Office Action Summary

10/786,740

UCHIYAMA, HIROMI

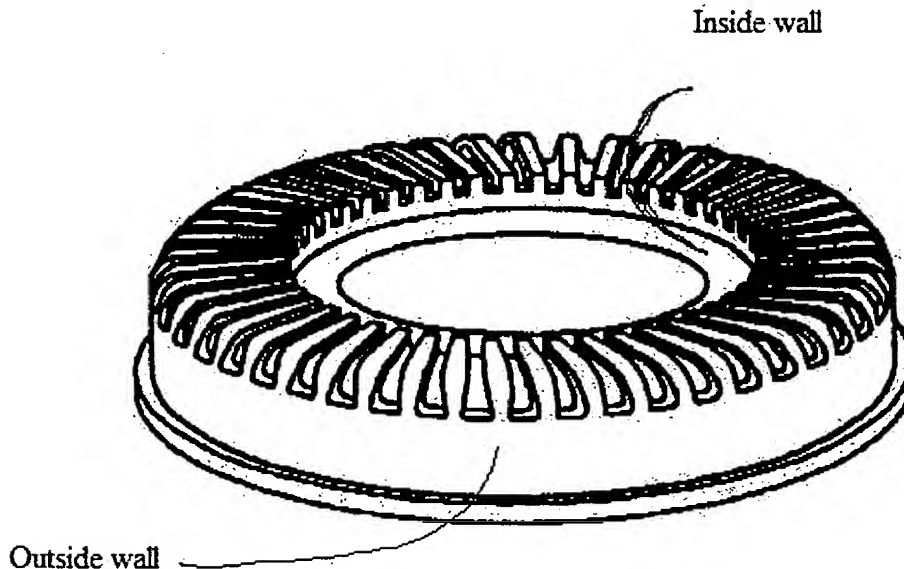
10. Regarding claim 9 depending on 1-5, Satoh further discloses that said shaving surface be in ring form (seen in figure 2) that there be an outside wall contiguous with

the outer circumference of said shaving surface, and an inner wall contiguous with an inner circumferential edge of said shaving surface (see figure below).

Satoh further discloses that upright members may be provided BOTH between said outside wall and inner cutter bodies and between said inside wall and said inner cutter bodies (both are shown in figure 14(a)).

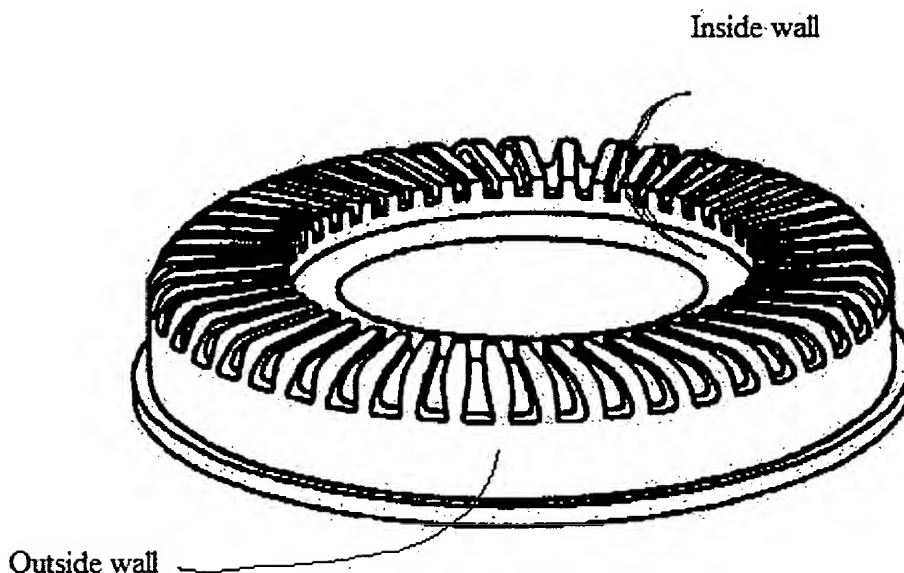
Satoh further discloses that said shaving surface be in ring form (seen in figure 2) that there be an outside wall contiguous with the outer circumference of said shaving surface, and an inner wall contiguous with an inner circumferential edge of said shaving surface (see figure below).

Satoh further discloses that upright members may be provided BOTH between said outside wall and inner cutter bodies and between said inside wall and said inner cutter bodies (both are shown in figure 14(a)).
